MOIR LANDSCAPE ARCHITECTURE

FEE PROPOSAL

Project: Proposed Mosque and Community Facilities
158A-164 Croudace Road, Elmore Vale
Response to Councils letter dated 21-12-2001 Reference 10/1049

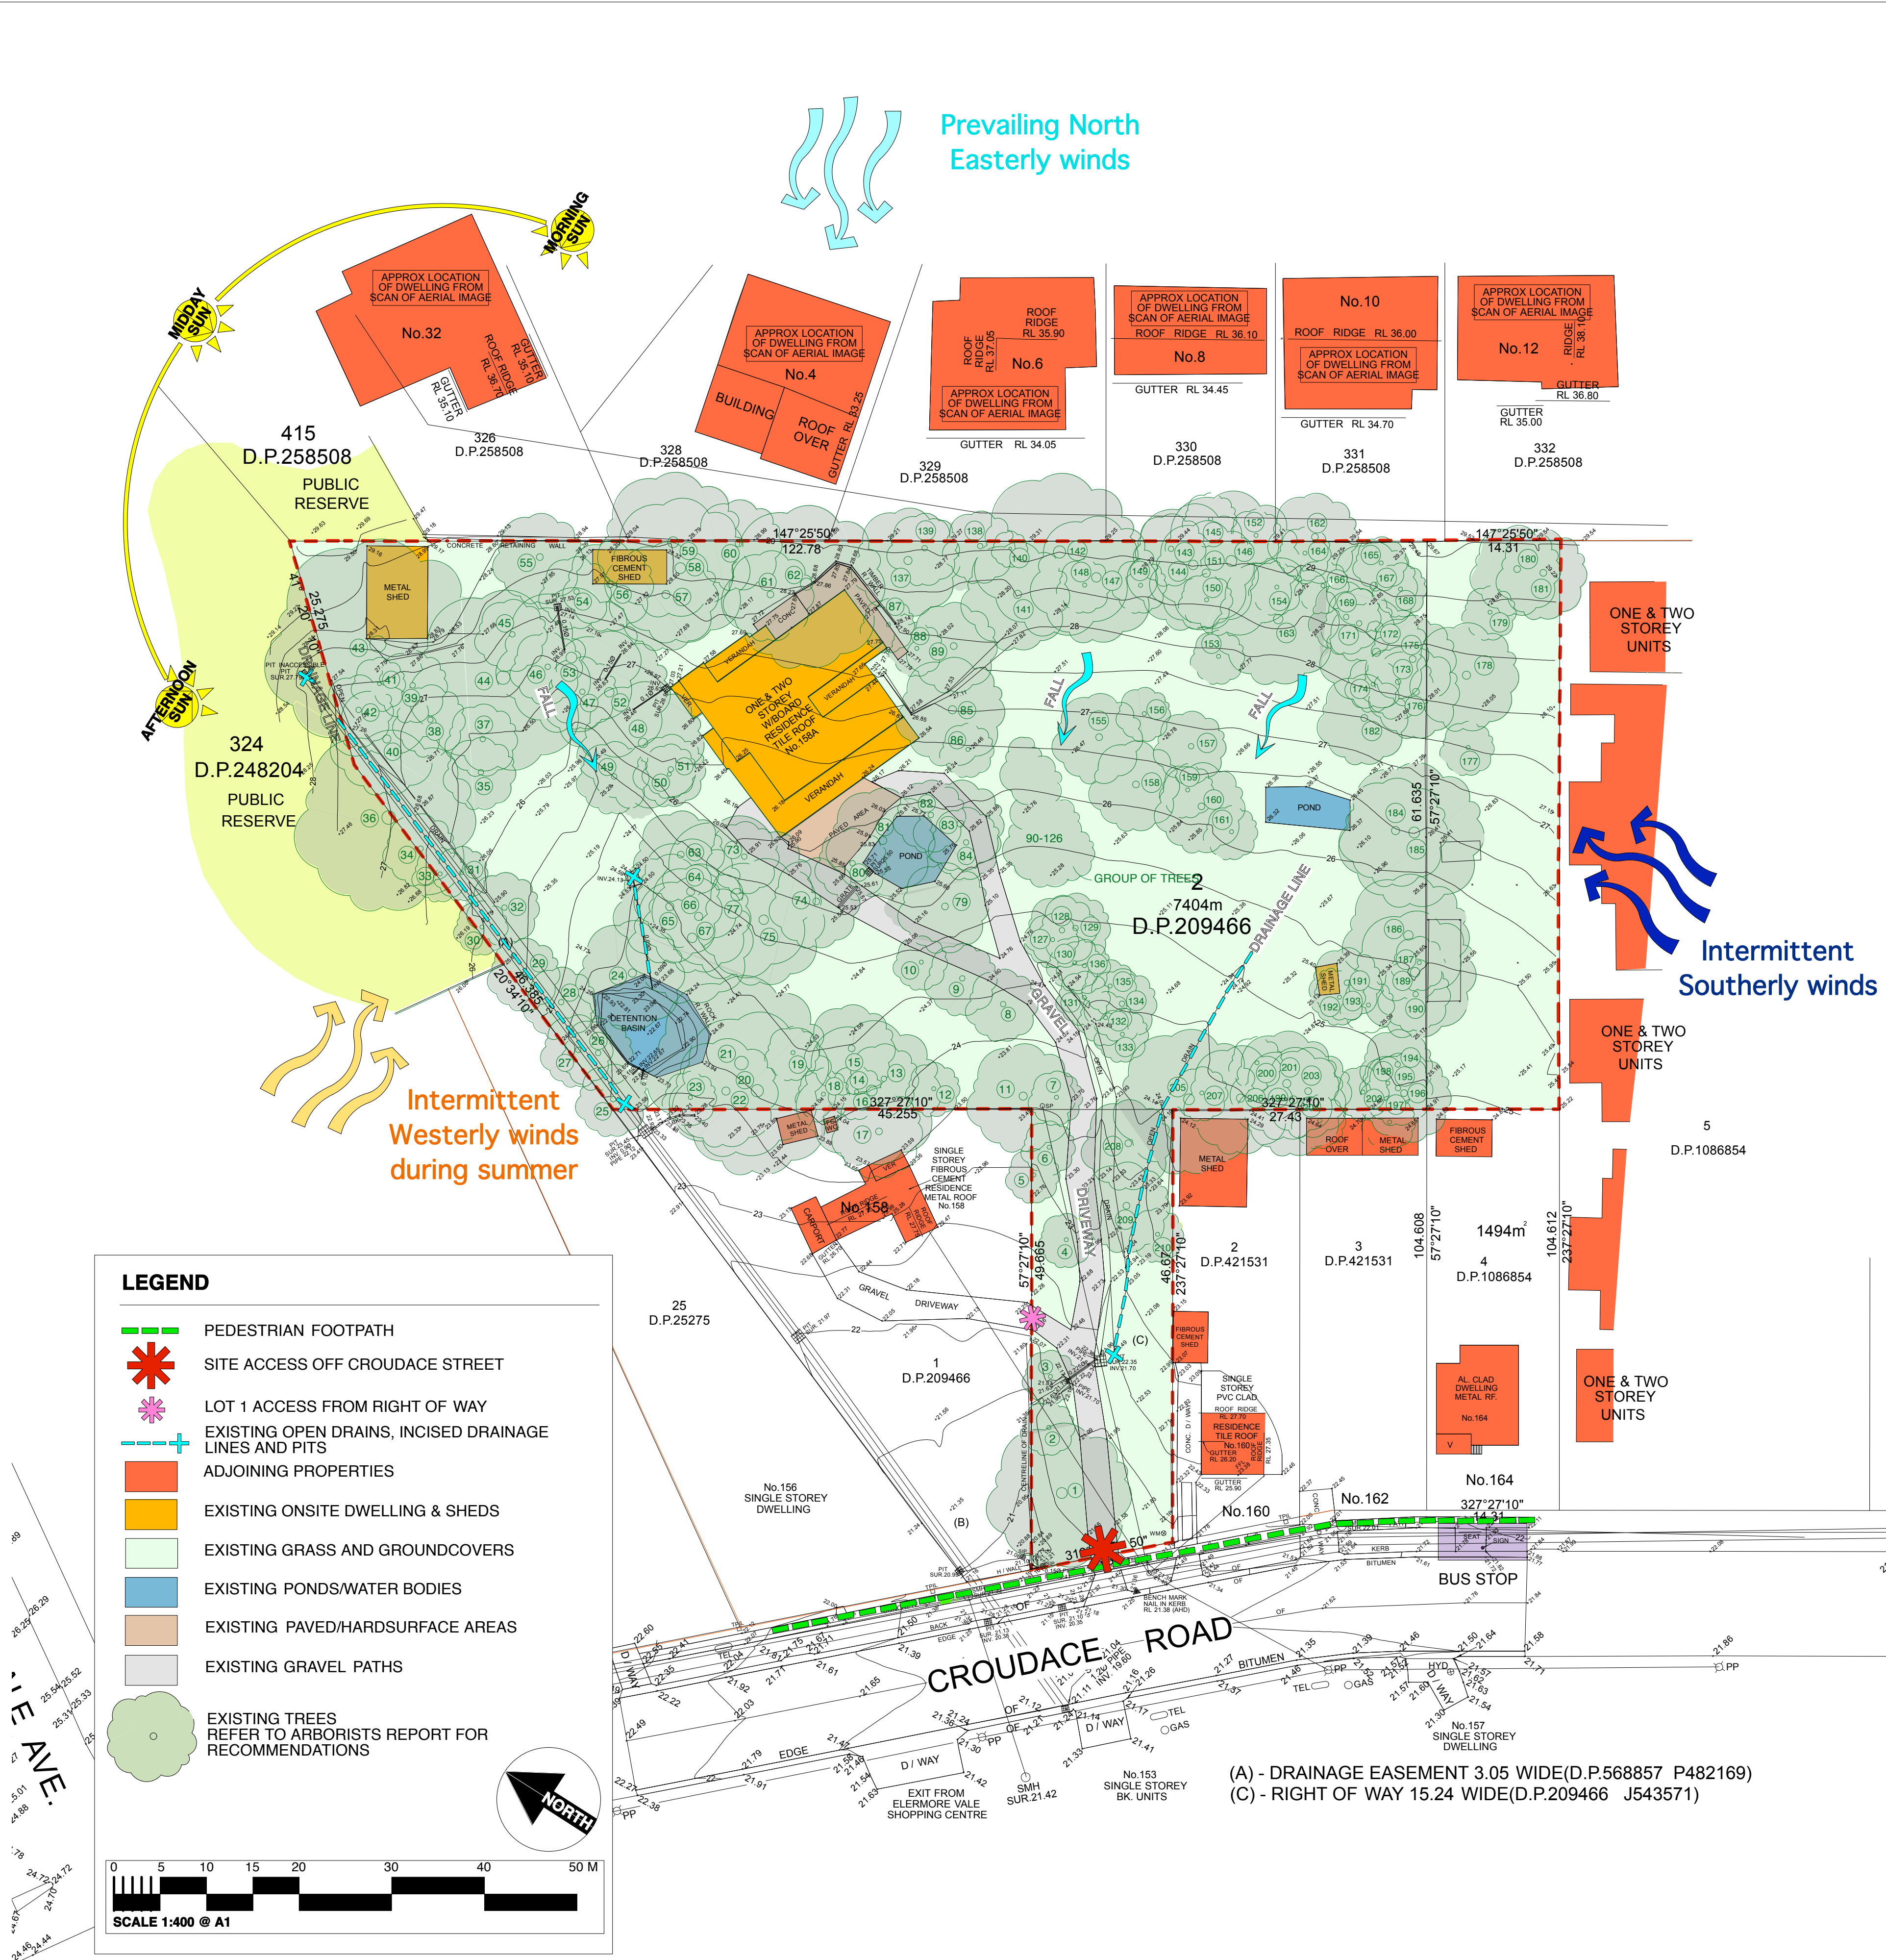
The Group noted that the proposal was currently quite internalized because of its largely 'landlocked' location, which is further reinforced by the proposed two metre high solid timber perimeter fence. While it is acknowledged that this is a necessary device to limit acoustic impact from vehicles on the site on neighbouring residents, the Group suggested that a more visually open timber screen fence facing the Public Reserve at the north of the site would assist in presenting a more Welcoming aspect to the public (while maintaining physical access via the driveway as proposed).

An open fence on the park side has been shown on the revised documentation.

Concept plan: Supplementary tree planting in neighbouring reserve.

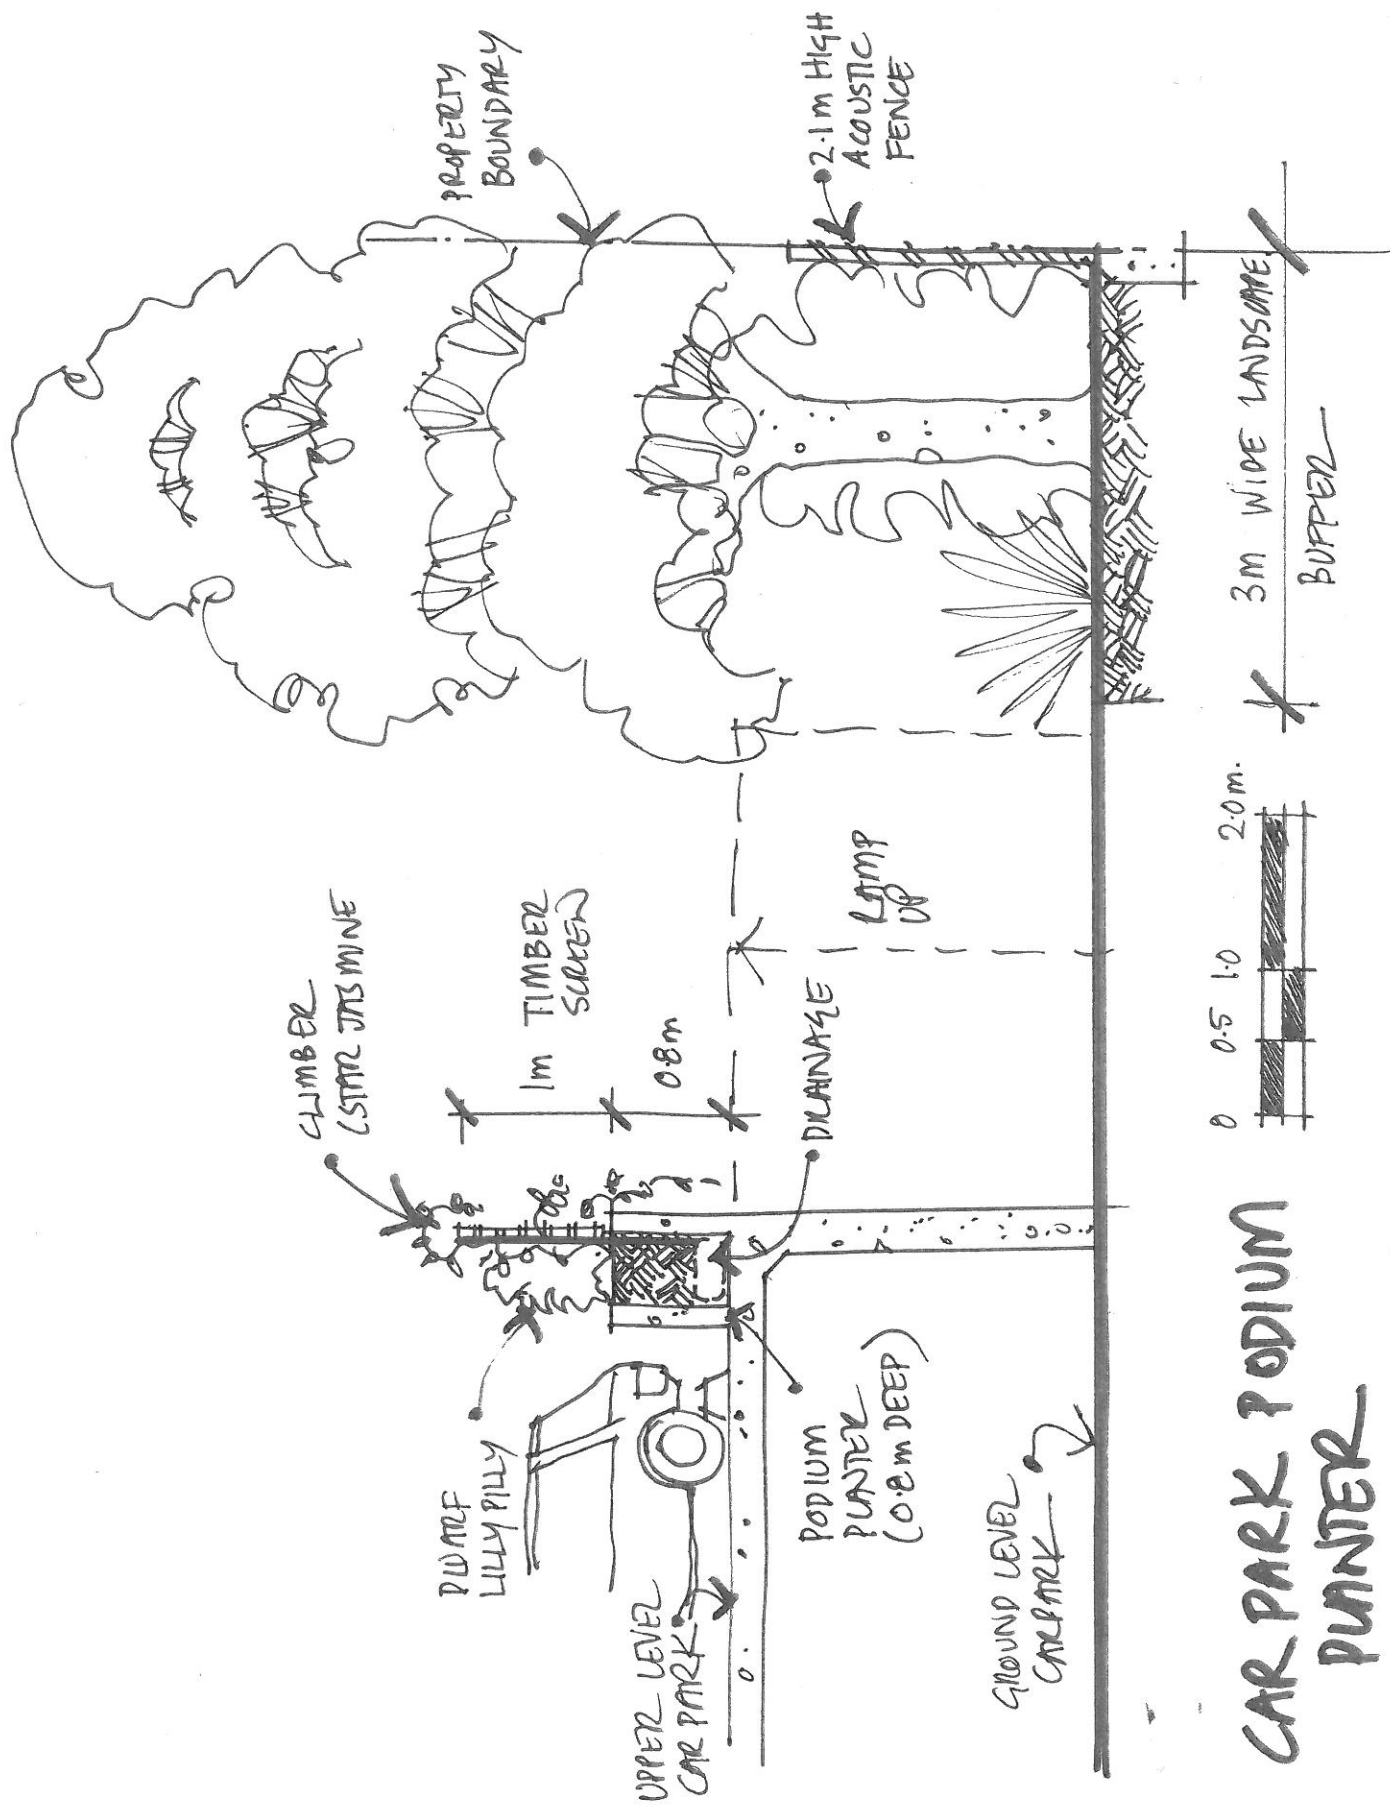
It is noted that the site contains a significant number of large trees and it is likely that compensatory planting would be required under the provisions of Element 4.10 (ie in addition to the number of trees proposed to be planted as part of the application). Investigation of the provision of compensatory tree planting (eg off-site) should be undertaken and provided to support the application in accordance with the provisions of Element 4.10. Alternatively, if compensatory planting is not being provided, it will be necessary to provide justification this non-compliance.

In addition to proposed tree planting shown on the landscape plan, a landscape concept plan has been prepared for the adjoining reserve

It should be noted that the arborist report identified trees that failed the VTA (ie. trees that are undesirable species and / or pose an unacceptable level of risk. The ad-hoc nature of the plantings makes it difficult for retention in light of any proposed development of this scale. Also, the general arrangement did not allow for many of the existing trees to grow to their full potential and makes replacing trees on a 1:1 ratio on site quite difficult. We have positioned trees to grow to their full potential rather than planting lots of trees in a small area. Additionally, a concept plan for the adjoining reserve showing potential locations for supplementary planting has been prepared for Council comment.
